# UNITED STATES PATENT AND TRADEMARK OFFICE

APPLICATION NO.	FILING DATE	FIRST NAMED INVENTOR	ATTORNEY DOCKET NO.	CONFIRMATION NO.
10/528,976	03/10/2006	Thomas Flehmig	20496-479	9171

<b>Office Action Summary</b>	<b>Application No.</b>	<b>Applicant(s)</b>	
	10/528,976	FLEHMIG ET AL.	
	<b>Examiner</b>	<b>Art Unit</b>	
	Debra Wolfe	3725

Fig.1

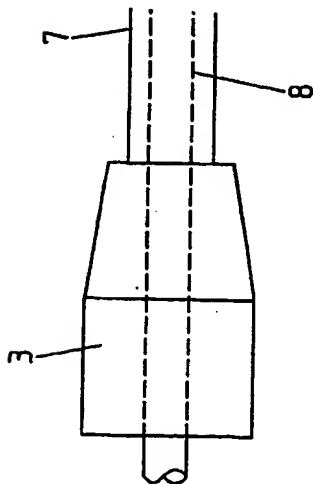
The drawings are objected to as failing to comply with 37 CFR 1.84(p)(5) because they do not include the following reference sign(s) mentioned in the description: round opening 4b and bending plane B. Corrected drawing sheets in compliance with 37 CFR 1.121(d) are required in reply to the Office action to avoid abandonment of the application. Any amended replacement drawing sheet should include all of the figures appearing on the immediate prior version of the sheet, even if only one figure is being amended. Each drawing sheet submitted
